FARRAGUT MUNICIPAL PLANNING COMMISSION

AGENDA

July 21, 2022

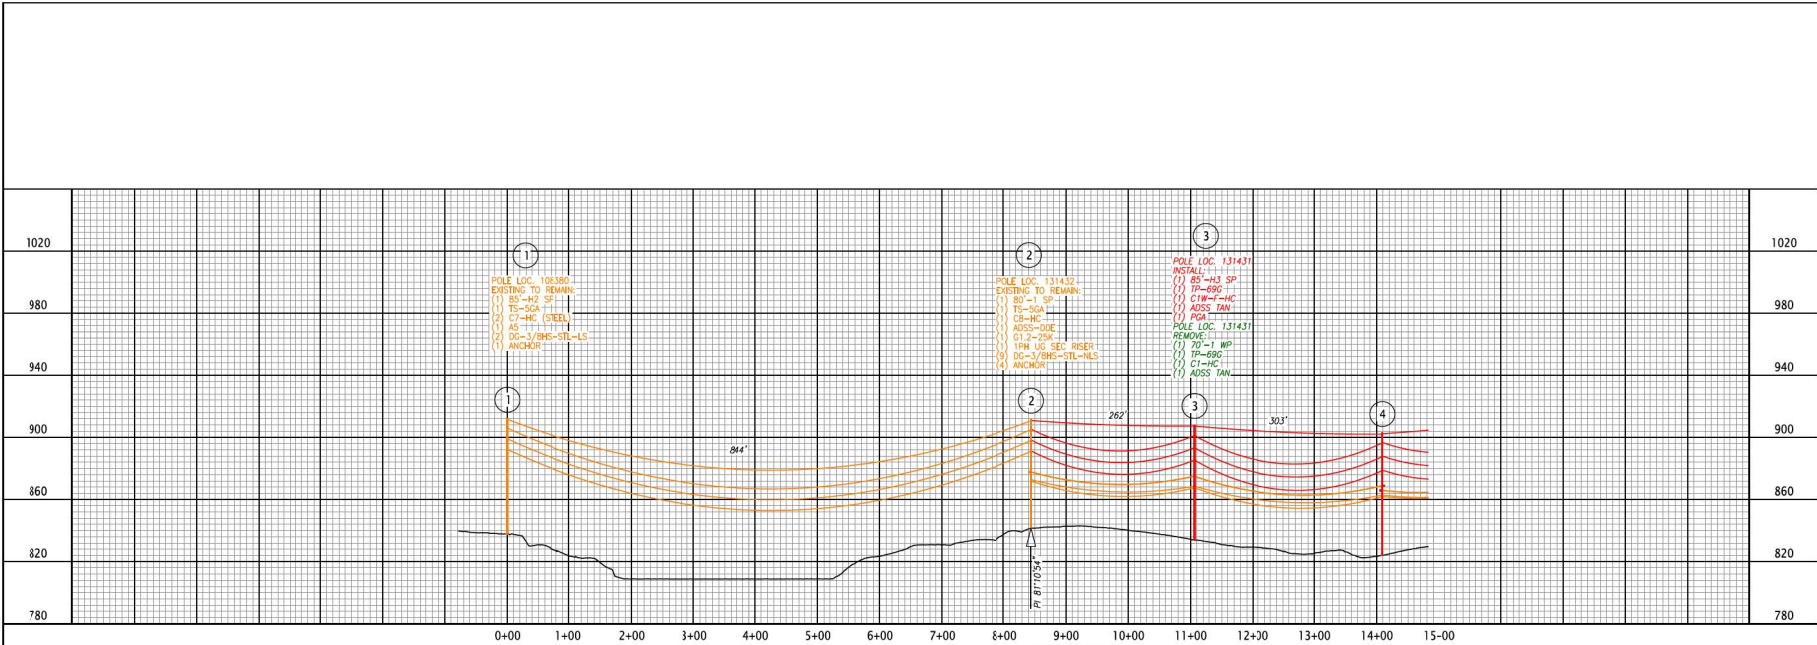
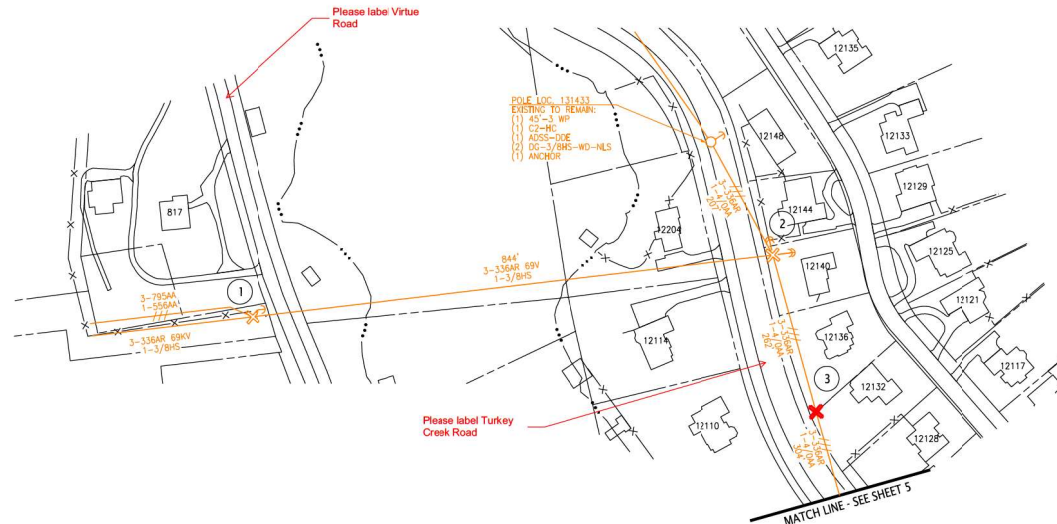
Final plan set will have to be signed and sealed.

Please include images of what the different replacement poles will look like in comparison with existing poles. On the images please call out materials and pole diameters.
Please include a cover sheet with a detailed summary of the scope of work, a listing of the sheets within the submittal, a location map, where lines are being abandoned, and a legend for all symbols used on the plans.

The location map should show the existing transmission line easement that is being used for the upgrade and the area where the line is being removed.

Many of the replacement poles are taller than existing poles. Again, it would be helpful to show visuals of what is existing vs. what is proposed.

**ELECTRICAL PLAN
AND PROFILE**

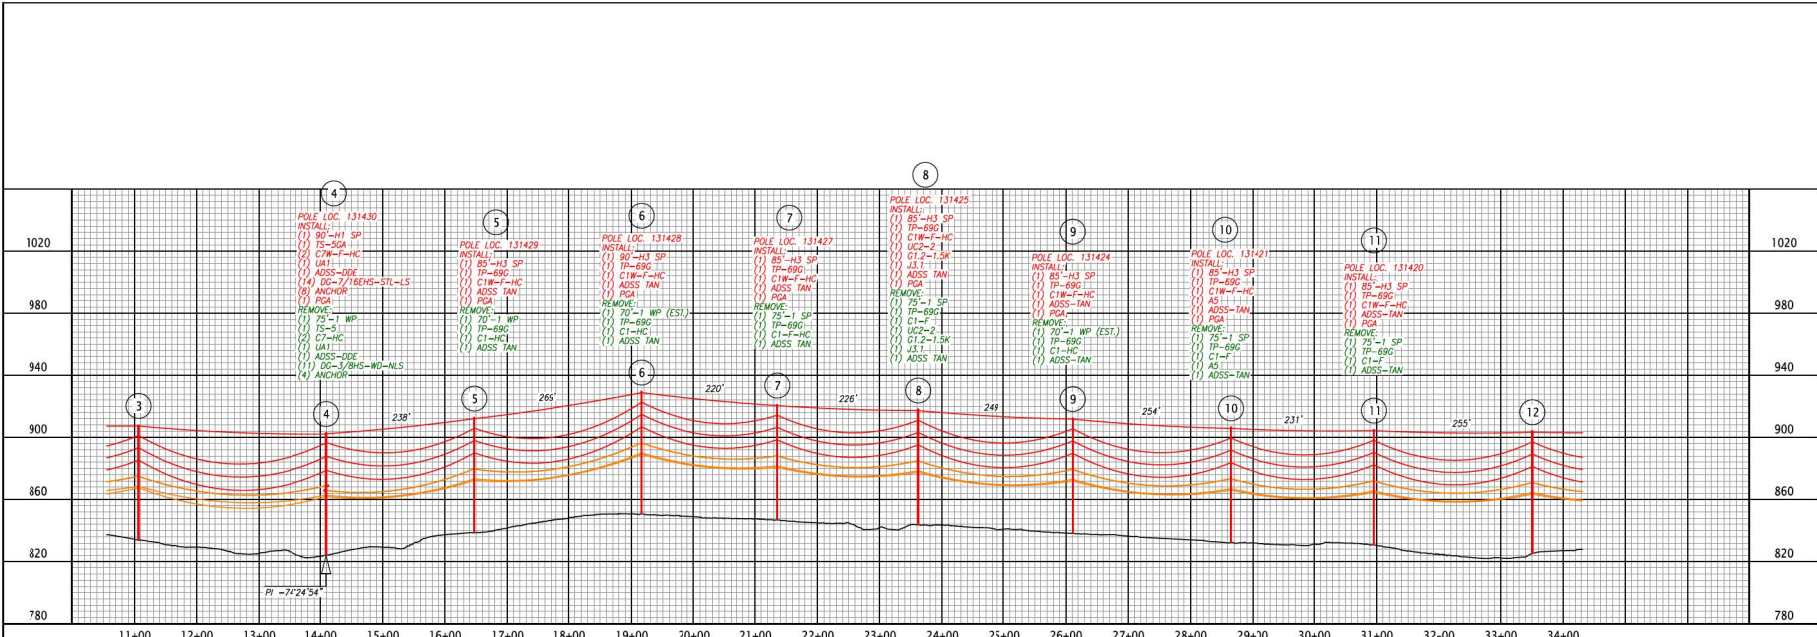
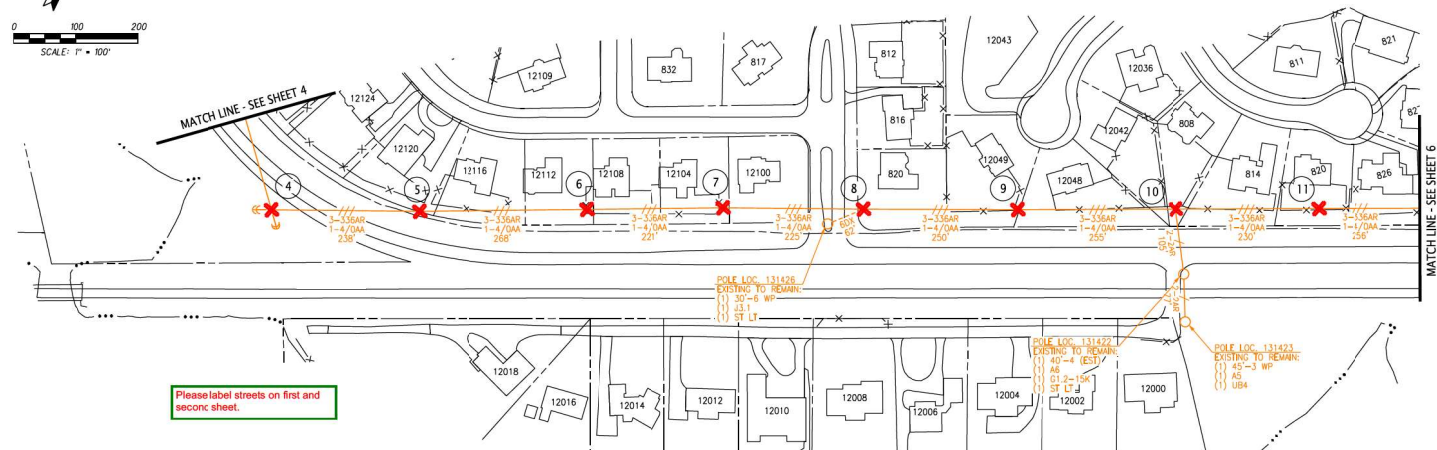
Please label streets on first and second sheet.

CP-1

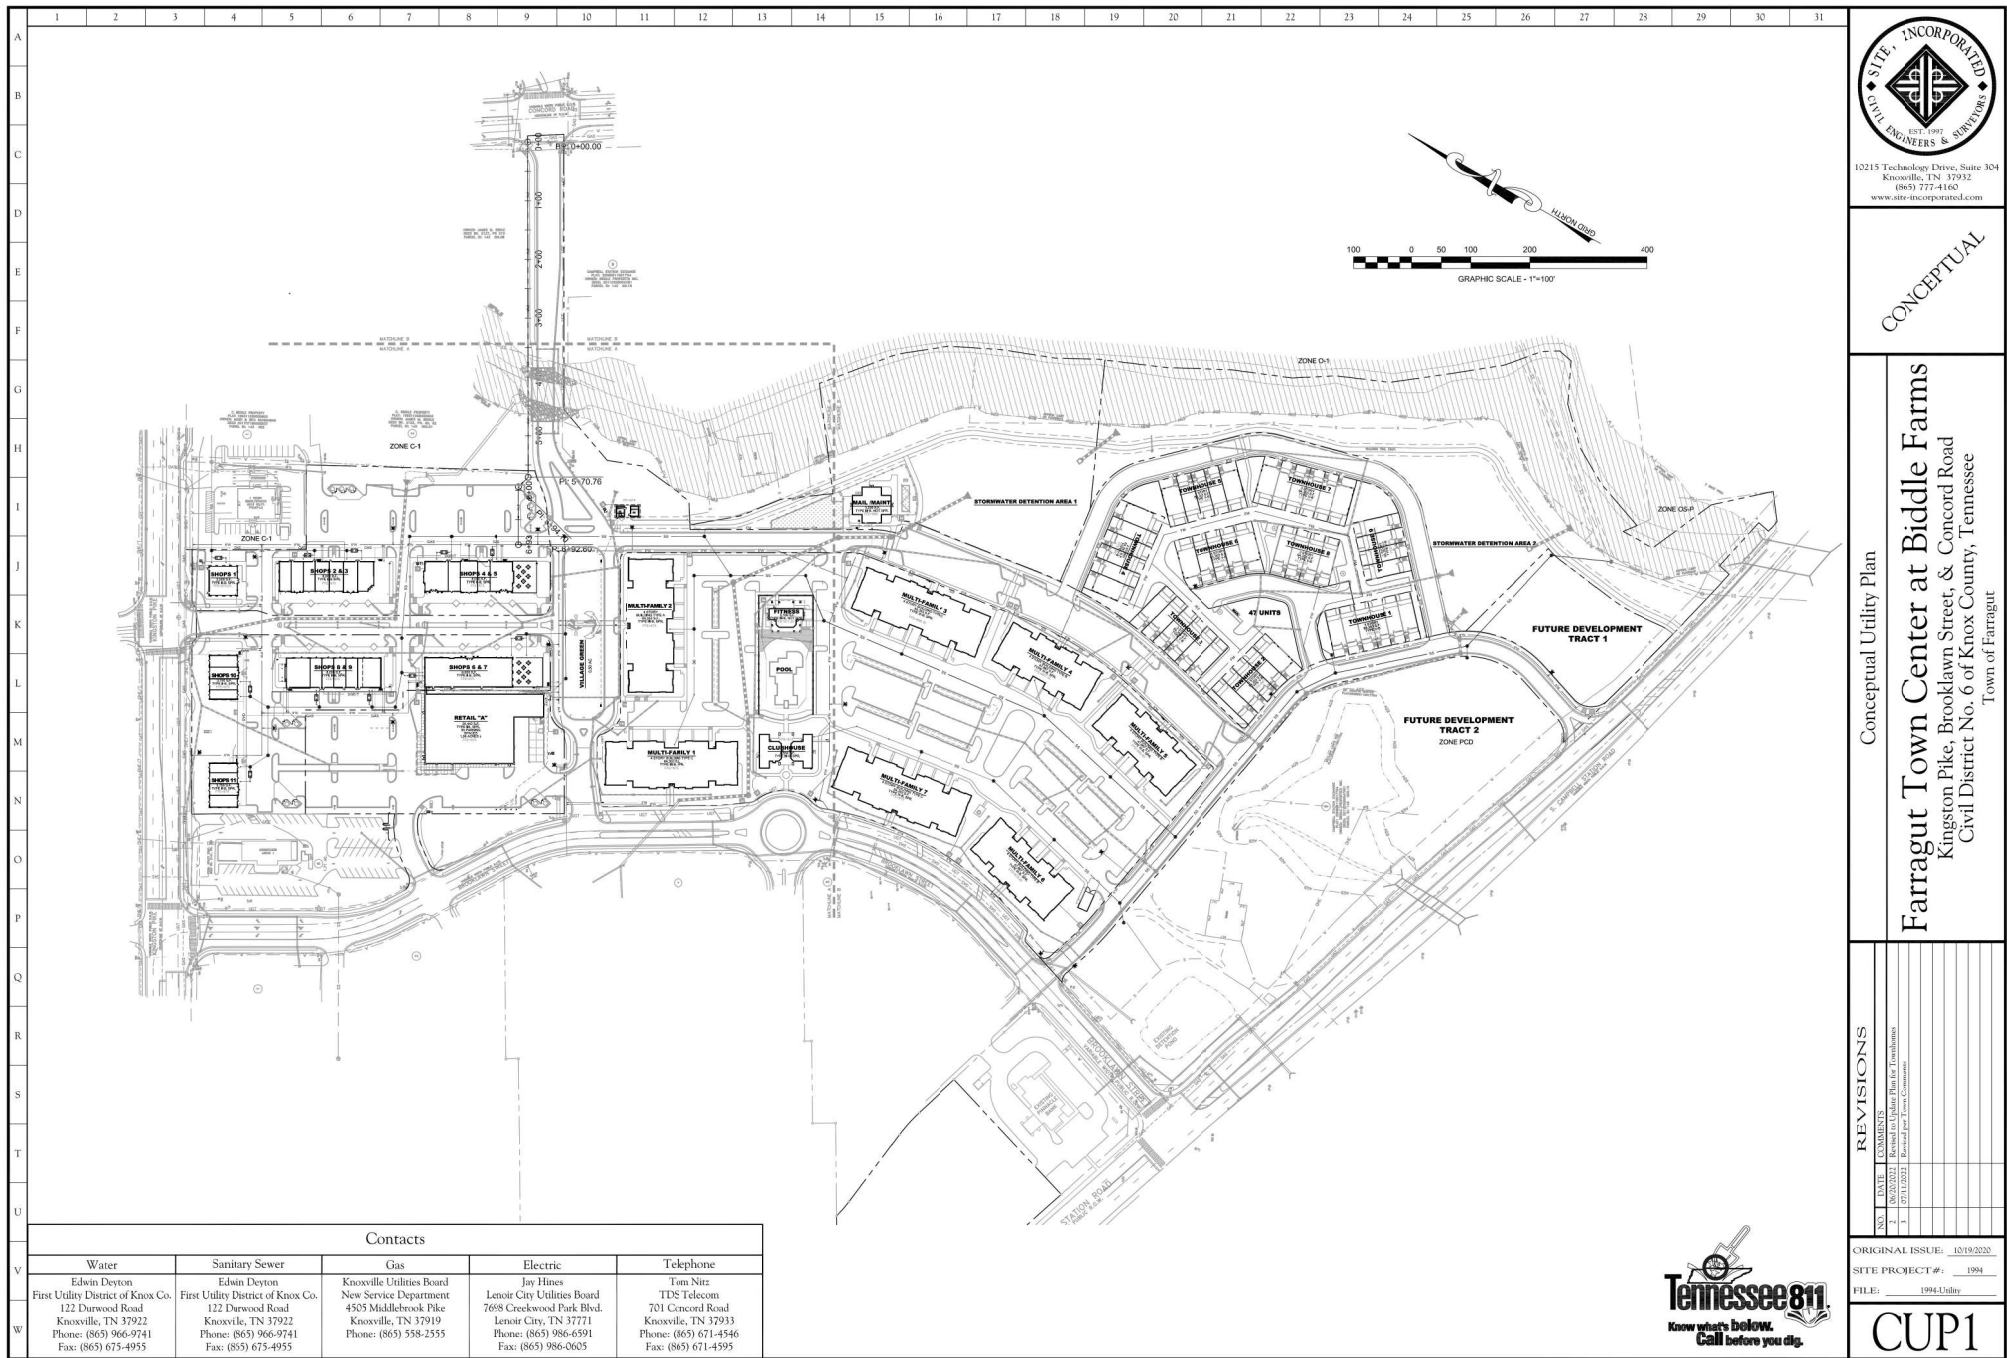
Please ensure that this table is updated for the townhome addition and is correct given the abutting zoning.

Please verify that with the townhome addition there is still at least 10% open space in this PCD project.

Please verify that these cross sections to be consistent with the stamped approved site plan set and to include the townhome street cross sections.

Can you please provide color renderings of the latest building elevations.

Height has been added to sheet CP-1

Tracts 1 & 2 have been labeled on the plans.
Refer to sheet CP-1

Table has been updated and adjacent zoning is shown on the plans. Refer to sheet CP-1

Yes. See the detail added to the Concept Plan for detailed info. Sheet CP-1.
